UNITED STATES PATENT AND TRADEMARK OFFICE

APPLICATION NO.	FILING DATE	FIRST NAMED INVENTOR	ATTORNEY DOCKET NO.	CONFIRMATION NO.
09/972,942	10/10/2001	Nobuyuki Suda	Q65006	4815

Office Action Summary	Application No.		Applicant(s)	
	09/972,942		SUDA, NOBUYUKI	
	Examiner		Art Unit	
	Mark Eashoo, Ph.D.		1732

DETAILED ACTION

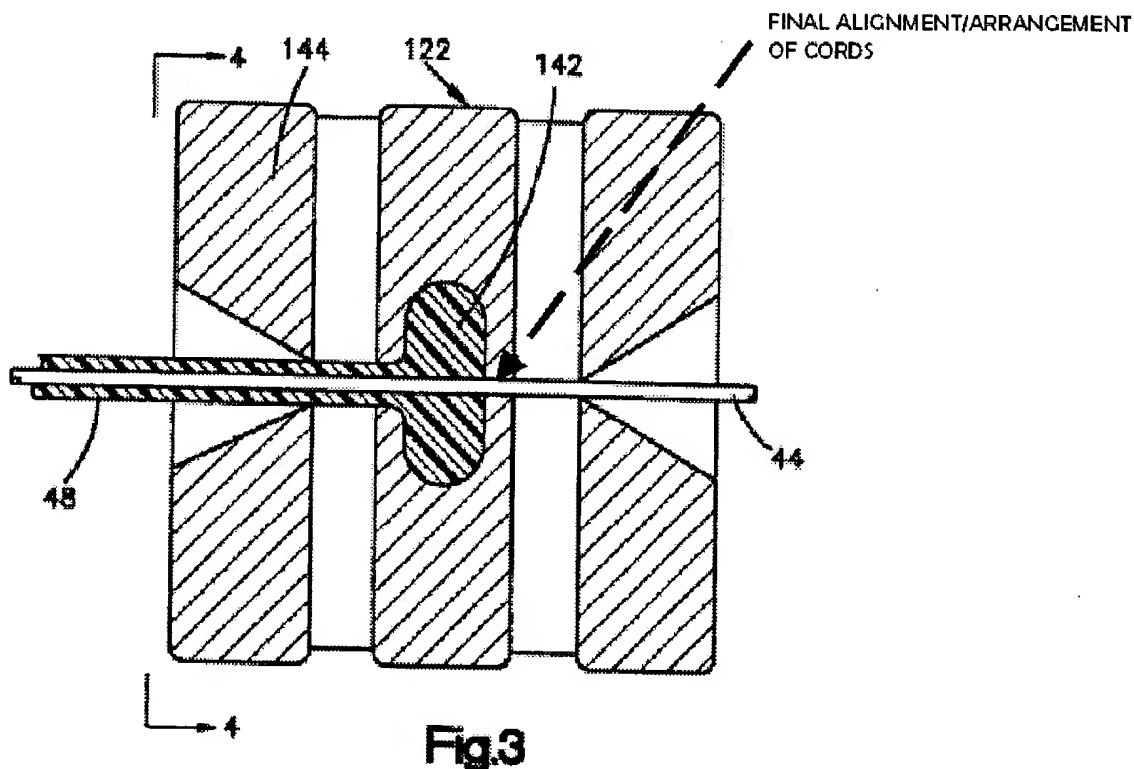
Although not explicitly taught by Vinson et al., the final alignment/arrangement of the cords is accomplished immediately before coating by a narrow passageway/insert in the extrusion head/die (see Fig. 3 below). The final alignment/arrangement of the cords is evidenced by the linear spatial separation of the cords as shown in Fig. 4. Alternatively, the breadth of the limitation "immediately after" is also able to be interpreted as "the following step/process without any steps between arrangement and coating" which is inherently met by Vinson et al.

Furthermore, the area of the structure (element 122) where the final alignment/arrangement of the cords takes place acts as the instantly claimed "inserter" since the cords are passed thorough this structure or passageways as set forth above.
